# ROBINSON HELICOPTER COMPANY

## SERVICE BULLETIN #53

SUBJECT: Cracks in Lower Vertical Fin Attachment Channels.

ROTORCRAFT AFFECTED: S/N 0002 thru S/N 0598

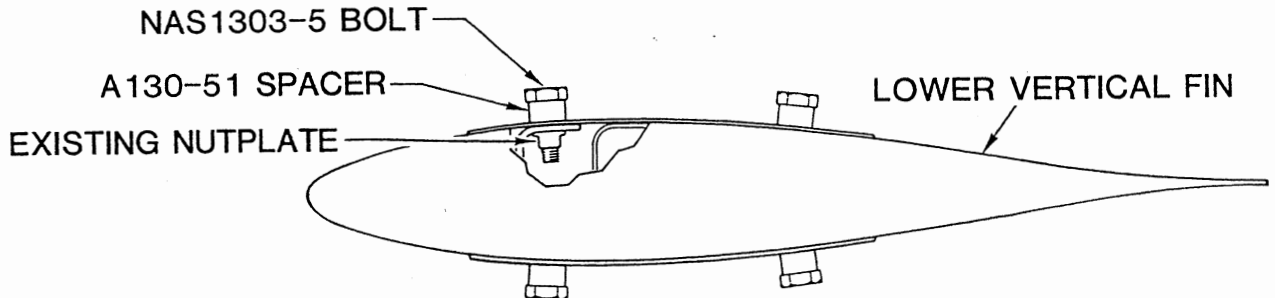
6. Reinstall the vertical fins using the bolts and spacers in the RHC KI-52 kit on the lower fin as shown below. Torque the NAS 1302-2 & -5 bolts on both fins to 60 inch pounds plus locking torque for optimum clamping.
